IN THE MATTER OF Submissions and Further Submissions on the Proposed Waimakariri District Plan by **Bellgrove Rangiora Limited**

**SUPPLEMENTARY EVIDENCE OF MICHELLE RUSKE-ANDERSON
IN RESPONSE TO OFFICER REPORT
ON BEHALF OF BELLGROVE RANGIORA LIMITED
REGARDING STREAM 12E**

DATED: 2 August 2024

Figure 2. BRL's Updated SER-ODP

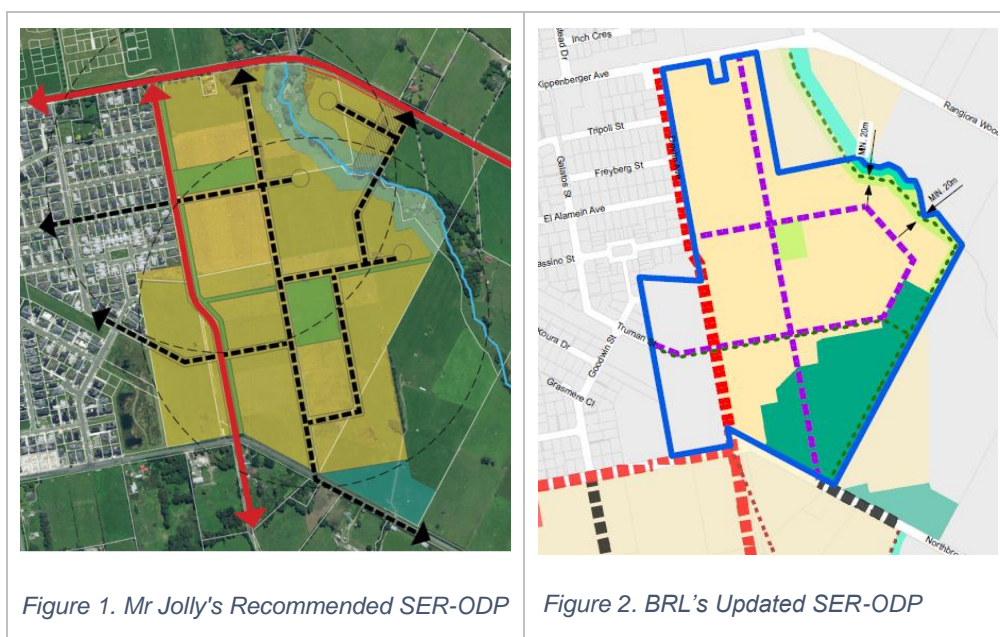
- 26 Instead, paragraph 606 of Officer Report A introduces Figure 41 titled 'Recommended updates to SER-ODP', which is substantially different to the Updated SER-ODP promoted by BRL (Attachment 1) as shown by the side-by-side comparison of Figures 2 and 3.

- 27 No legend is provided alongside Mr Jolly's Recommended SER-ODP but I note the key differences within the Bellgrove South landholding as:
- (a) The absence of the large 6.5ha stormwater reserve within the south eastern corner of the Site required for stormwater management of Bellgrove South¹⁴ (Mr Delagarza inputted into the development of the Bellgrove updated SER-ODP and the Stormwater Reserve area shown has been sized to ensure that hydraulic neutrality is achieved for the Site)¹⁵;

- (b) Changes to the internal road network within Bellgrove South, including the inclusion of a secondary road network within the required stormwater management area. These do not lead to better transport outcomes for the Site or a more well-functioning transport network than the Bellgrove Updated SER-ODP¹⁶;

- (c) Changes to the number and location of the open space reserves and amendments to the green space approach which do not result in a better urban amenity outcome than that promoted by the Updated SER-ODP¹⁷;

- 28 For the reasons outlined above I consider that the Updated SER-ODP would result in a more appropriate and well-functioning urban environment than that put forward by Mr Jolly in Figure 41 of Officer Report A.

- 30 Should the Panel be of a mind to adopt any or all of Mr Jolly's recommendations supported by the Officer then it would be most appropriate that these recommendations are made using the updated SER-ODP as the base template (not Figure 41 which at a minimum shows a substandard internal road network and does not provide adequate stormwater management reserve area), noting for the following reasons that BRL oppose some of those recommendations.

Figure 3. Extent of Bellgrove North not identified within Figure 28 of Officer Report A

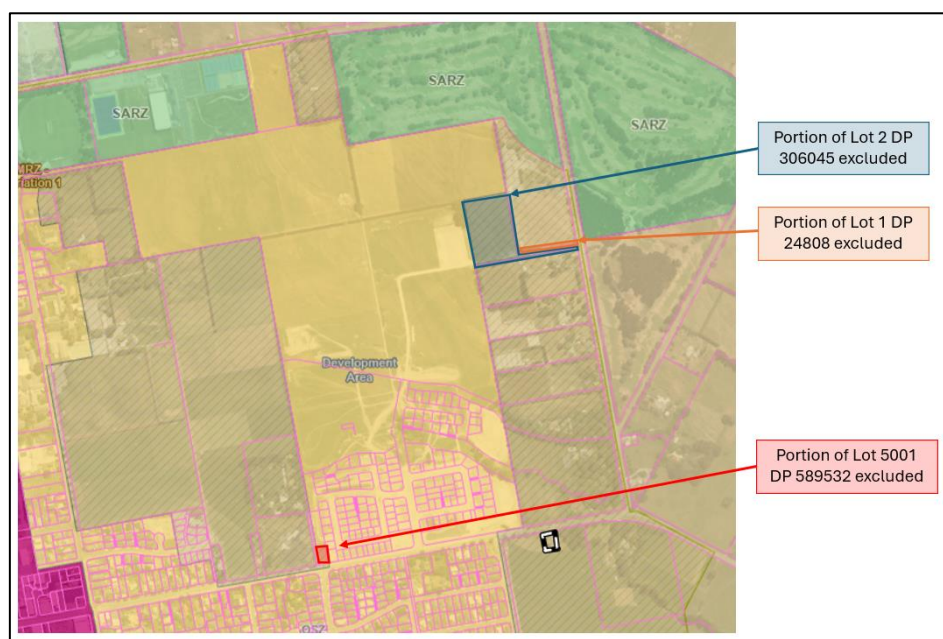
- (b) Figure 28, which is referenced in paragraph 409 of Officer Report A does not correctly show the full extent of Bellgrove North. It excludes a portion of Lot 1 DP 24808 and some additional minor areas of Lot 2 DP 306045²⁴ and Lot 5001 DP 589532 (refer Figure 1).

Figure 4. Bellgrove North Land recommended for inclusion for Variation 1 Medium Density Residential

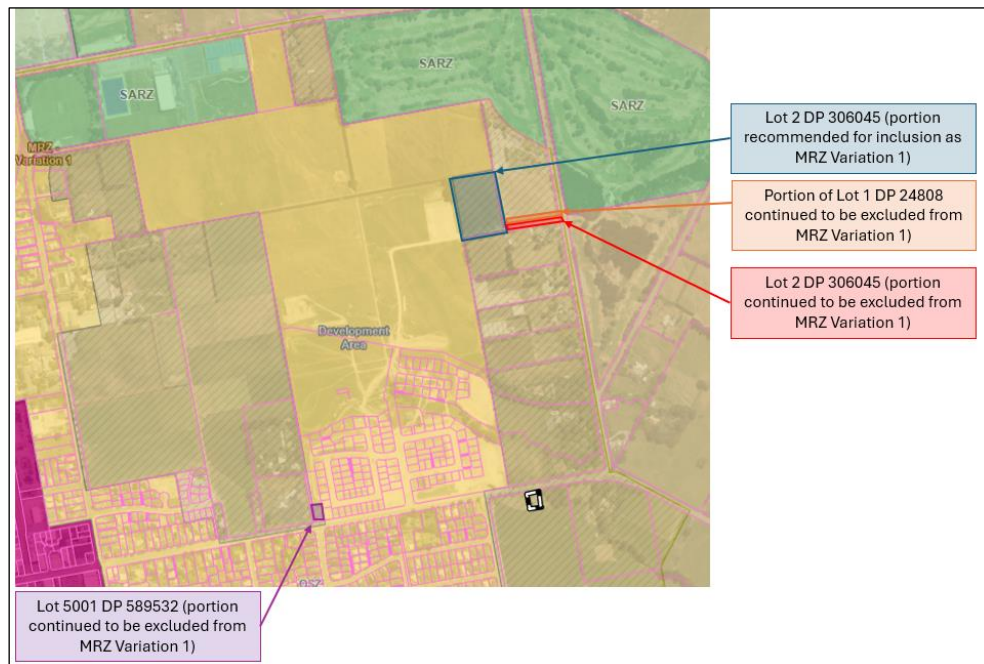
- 46 Whilst the Officer acknowledges a parcel of land in the development area was inadvertently left out of the Variation 1 maps at paragraph 176 (the area identified in blue on Figure 4 below) there remains some of the Bellgrove North land excluded.

- 47 This recommendation would leave two small areas of Bellgrove North land as PWDP MRZ as opposed to Variation 1 MRZ. These are shown in Figure 4 below and comprise:

- (a) **The Future East West Collector Road:** A portion of land 145 m long by 22m wide that will form the 22m wide East West Collector Road to be established in accordance with the NER-ODP and connecting Bellgrove North to Golf Links Road, which will comprise:

- i. a 10m-wide access leg of Lot 2 DP 306045 that connects to Golf Links Road (shown in red in Figure 4); and
 - ii. a 12m-wide strip that will be acquired from Lot 1 DP 24808 to enable the required width to form the 22m wide East West Collector Road (shown in orange in Figure 4); and

- (b) **Road 1:** A portion of Lot 5001 DP 589532 which has already been formed as Road 1 within Stage 1 (shown in purple in Figure 4).

- 48 The portion of Lot 5001 DP 589532 which has already been formed as Road 1 within Stage 1 was also shown for inclusion within the s32 Report for Variation 1²⁶ and consequently for the same reasons as the Officer outlines in paragraph 186 I consider that this should also be included to rectify the error.
- 49 The area of land which will form the Future East West Collector as the Officer notes will not be developed as housing. Despite this, I consider it an unusual approach to exclude it when all other roads and accesses associated with Bellgrove North are recommended to rezoned Variation 1 MRZ.

Figure 1A-1. Updated SER-ODP – 29 July 2024 DWG Reference: 509177-W00001-GIS-UU-0002

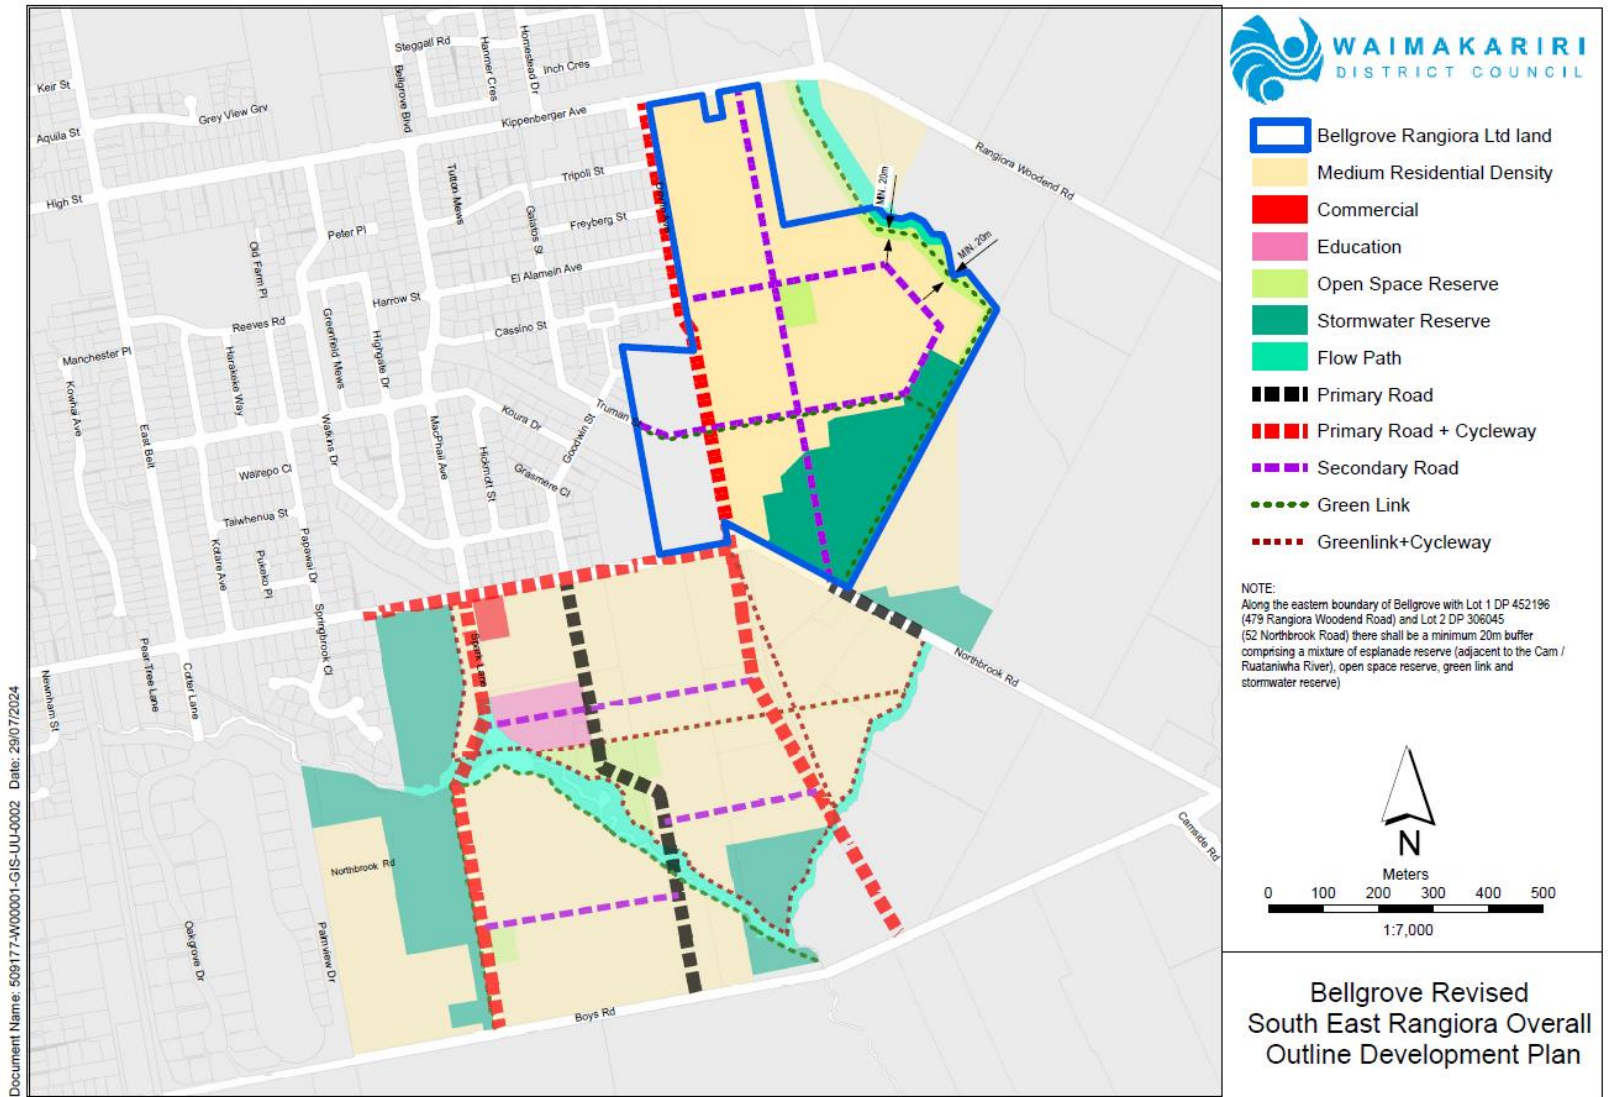
- 19 For completeness, **Attachment 1** comprises an Updated SER-ODP (**Updated SER-ODP**) which includes a notation and mark up showing that the green buffer should be 20m wide minimum to provide assurances that the updated SER-ODP would meet the intent of this recommendation. The legend notes '*Along the eastern boundary of Bellgrove with Lot 1 DP 452196 (479 Rangiora Woodend Road) and Lot 2 DP 306045 (52 Northbrook Road) there shall be a minimum 20m buffer comprising a mixture of esplanade reserve (adjacent to the Cam / Ruataniwha River), open space reserve, green link and stormwater reserve.*'

- 18 A 20m-wide green buffer along the eastern boundary of Bellgrove South as shown on the SER-ODP SE#1 remains appropriate and fit for purpose (as opposed to 40m as suggested by paragraph 568) given:

- (e) Attachment 1 of this Supplementary Evidence dated 2 August 2024 provides further clarification of the eastern boundary 20m green buffer width minimum and is hereby referred to as the '**Updated SER-ODP**'.
